LANDSIDE ACCESS MODERNIZATION PROGRAM

ITF-W_A Interim Ground Access (IGA) **Project # DA-5305A**

Package Transmitted For	Delivered Via	Tracking Number
CO-0008-PDG FULLY EXECUTED ITF-W A Interim Ground Access (IGA) Change Order #08 for CPCN No# 1007A, 1004A, 1003A, and 1011A 2019-06-21		CO-0008-PDG FULLY EXCUTED

CHANGE ORDER NO. 0008

Unforeseen Storm Drain Line Near Sanitary Sewer Line
Connection Location.

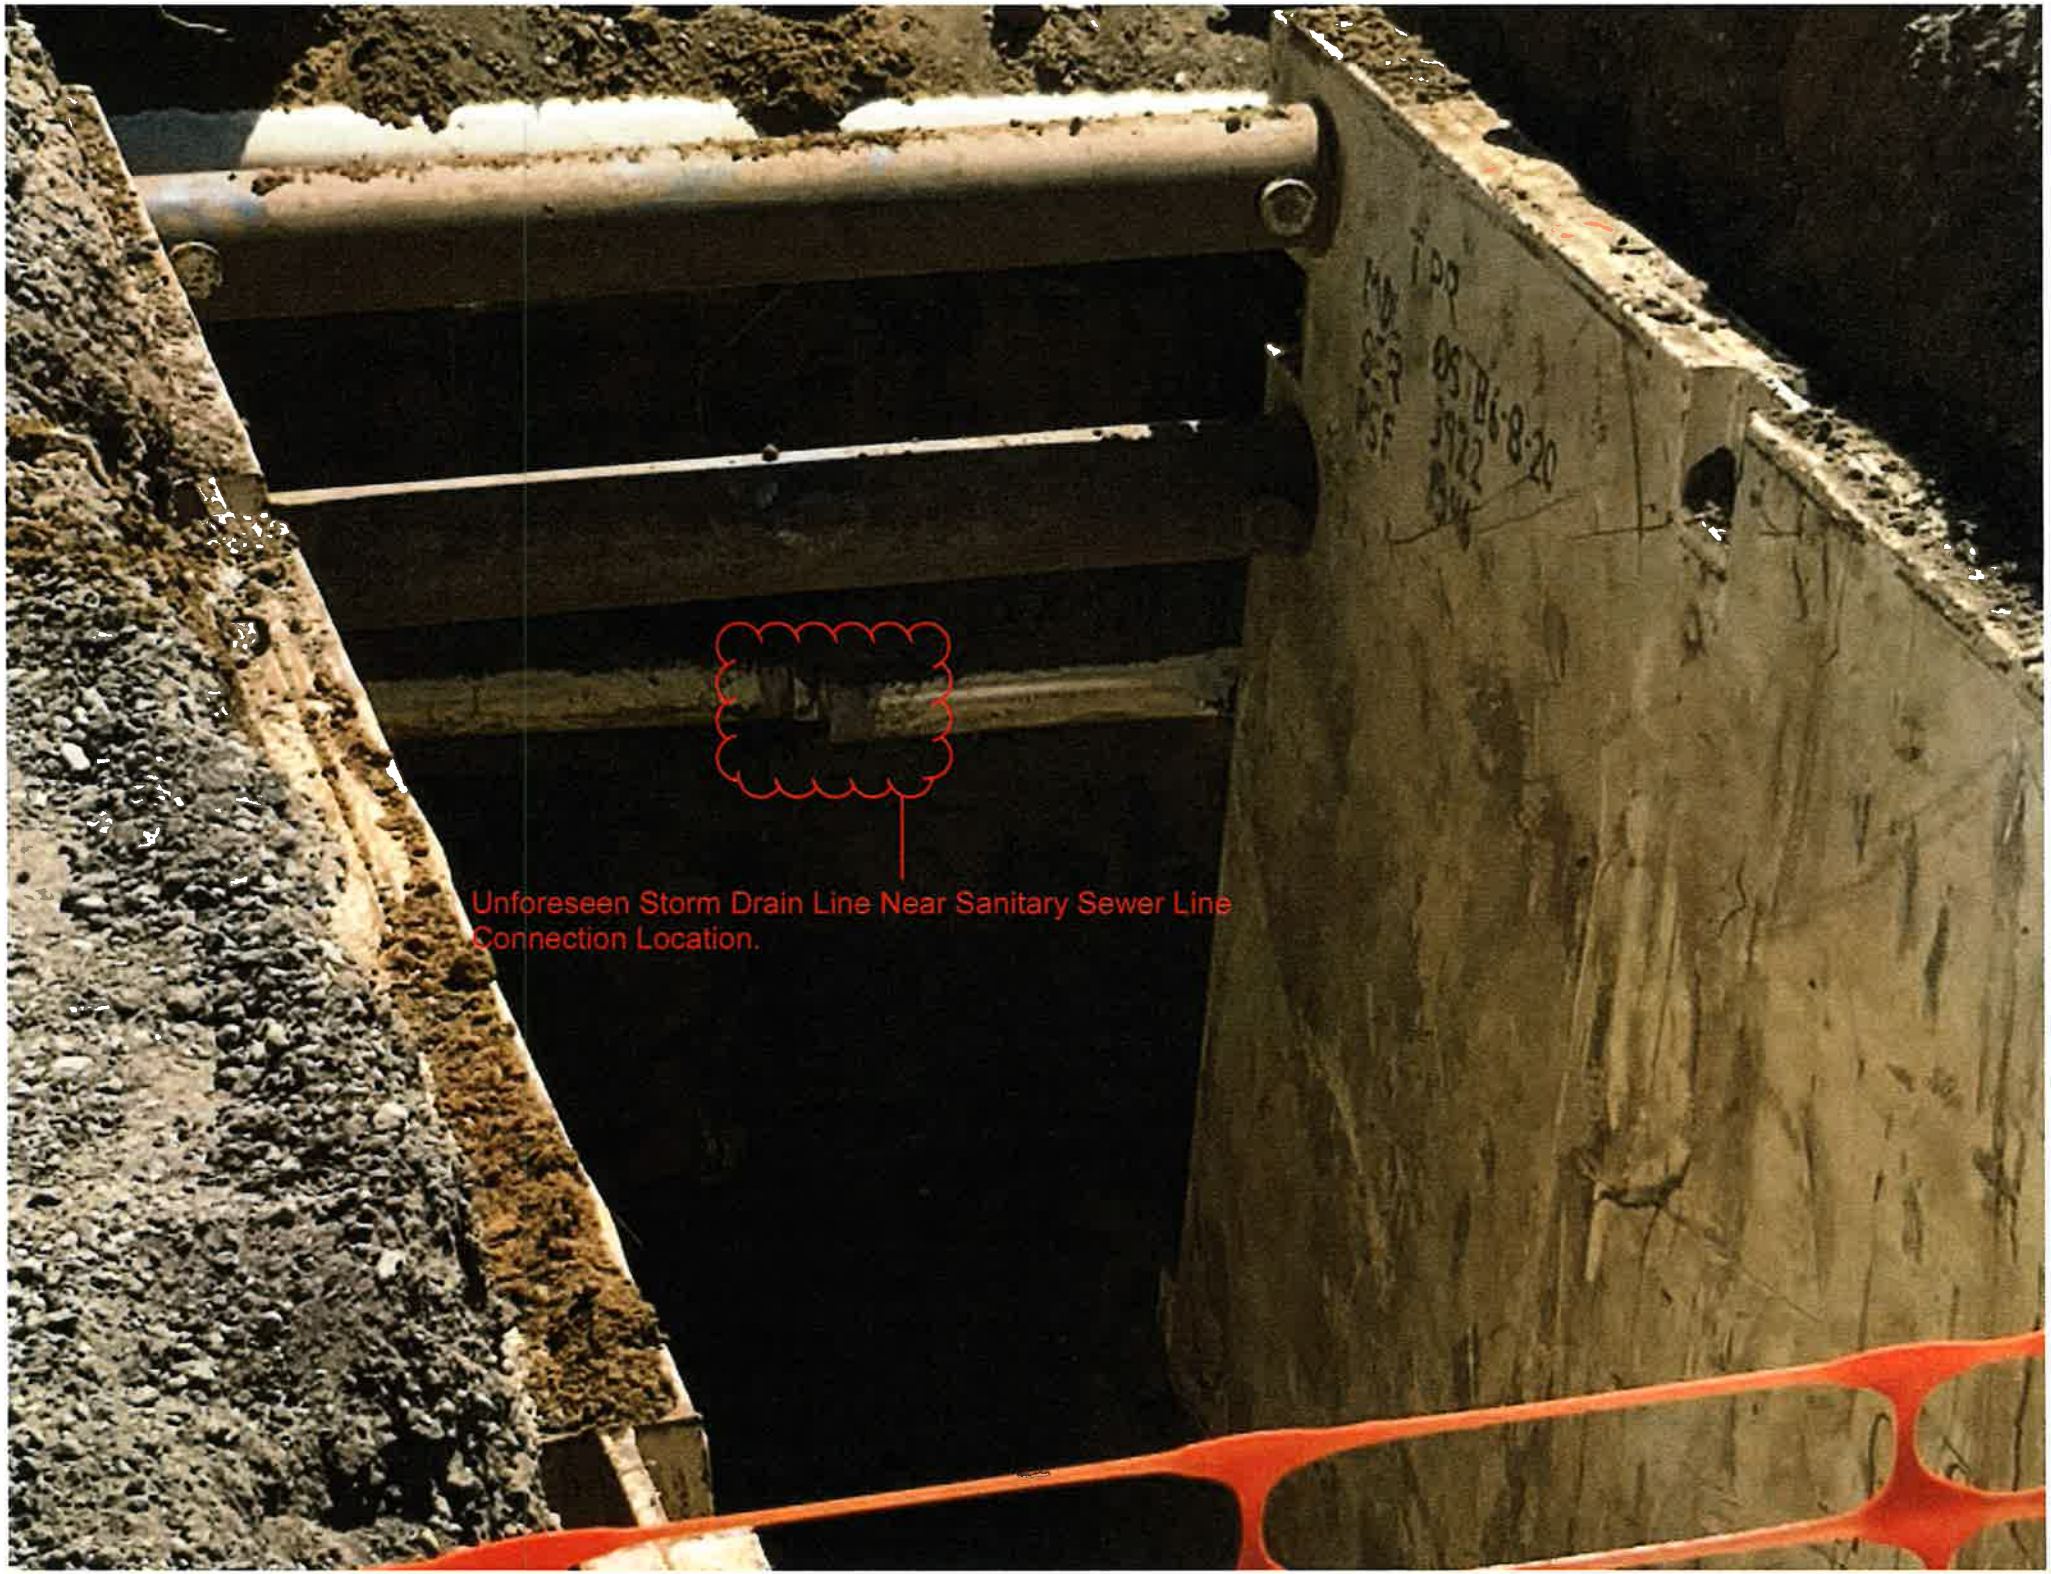
Unforeseen Storm Drain Line Near Sanitary Sewer Line Connection Location
LEGEND:
GENERAL NOTES:
UTILITIES NOTICE
KEYMAP
AIRPORT POLICE PARKING FACILITY
HONEYWELL TREATMENT FACILITY
SKYWAY
MATCHLINE - SEE SHEET C202
HNTB
LAX
Los Angeles World Airports
BUS DROP OFF EXISTING CONDITIONS PLAN 1
C201
20180516

If the existing drain line is abandoned, it is acceptable to remove interfering portions or abandon it. Otherwise, it should be repaired.
